PREPARED 1/03/17, 14:26:44 INSPECTION TICKET PAGE Harnett County INSPECTOR: IVR DATE 1/04/17

ADDRESS . : 1206 STEWART RD

APPL NUMBER: 16-50039494 CP NEW RESIDENTIAL (SFD)

Gaskins Residence

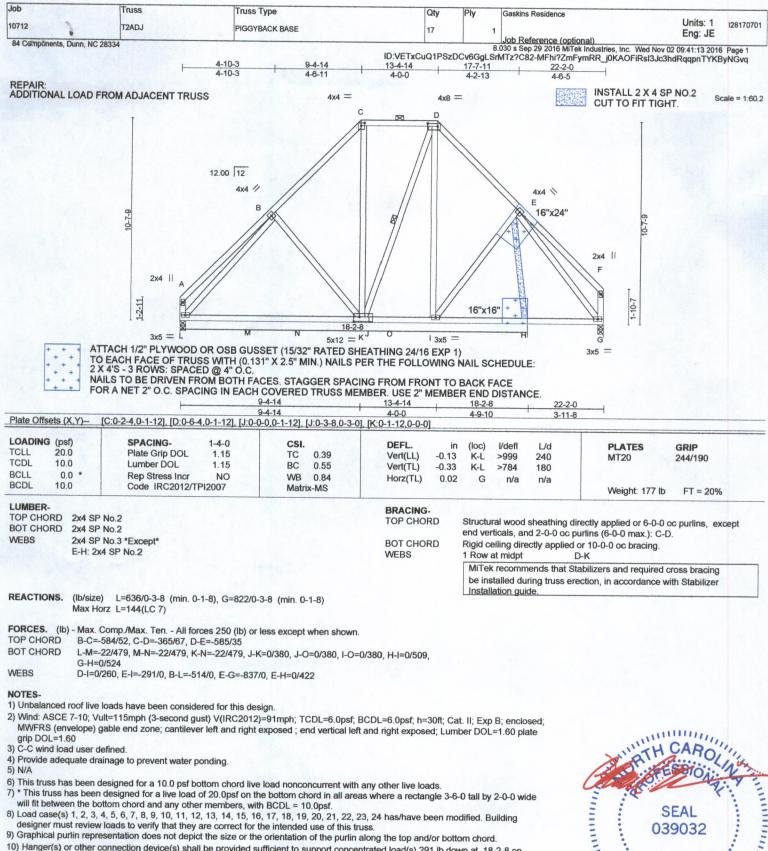
SF 00 CP * SFD REQUESTED INSP COMPLETED RESULT	DESCRIPTION RESULTS/COMMENTS
B101 01	9/21/16 DT 9/21/16 DA	R*BLDG FOOTING / TEMP SVC POLE VRU #: 002874198 T/S: 09/21/2016 03:10 PM DETAYLOR No markers for footing depth
B101 02	9/27/16 DT 9/27/16 AP	R*BLDG FOOTING / TEMP SVC POLE TIME: 17:00 VRU #: 002877298 T/S: 09/26/2016 02:43 PM LBENNETT T/S: 09/27/2016 03:40 PM DETAYLOR
	10/05/16 TW 10/05/16 AP	ADDRESS CONFIRMATION TIME: 17:00 VRU #: 002881084  1206 Stewart Rd Dunn 28334  ***# must be posted on home AND beside entrance/driveway Mailbox OK ONLY IF it is beside driveway. TWard 814-6372  T/S: 10/05/2016 08:28 AM TWARD
	10/05/16 DT 10/05/16 AP	R*BLDG FOUND & TEMP SVC POLE TIME: 17:00 VRU #: 002880664 T/S: 10/04/2016 08:28 AM LBENNETT
	10/18/16 DT 10/18/16 AP	R*OPEN FLOOR TIME: 17:00 VRU #: 002885796  T/S: 10/17/2016 10:08 AM LBENNETT T/S: 10/18/2016 12:26 PM DETAYLOR
	12/07/16 DT 12/07/16 DA	FOUR TRADE ROUGH IN TIME: 17:00 VRU #: 002907624  T/S: 12/06/2016 01:58 PM LBENNETT  T/S: 12/07/2016 12:28 PM DETAYLOR  Need paperwork for altered trusses  Strap stud columns  Need repair letter for broken truss at storage space  Okay to side and insulate

APPLY 2 X 4 X 4' SPF/DF/SP NO.2 SCAB(S) TO EACH FACE OF TRUSS AS SHOWN. ATTACH WITH (0.131" X 3") NAILS PER THE FOLLOWING NAIL SCHEDULE: 2 X 3"S - 1 ROW, 2 X 4"S - 2 ROWS, 2 X 6"S AND LARGER - 3 ROWS: SPACED @ 4" O.C. STAGGER NAIL SPACING FROM FRONT FACE AND BACK FACE FOR A NET 2" O.C SPACING IN THE TRUSS. USE 2" MEMBER END DISTANCE.
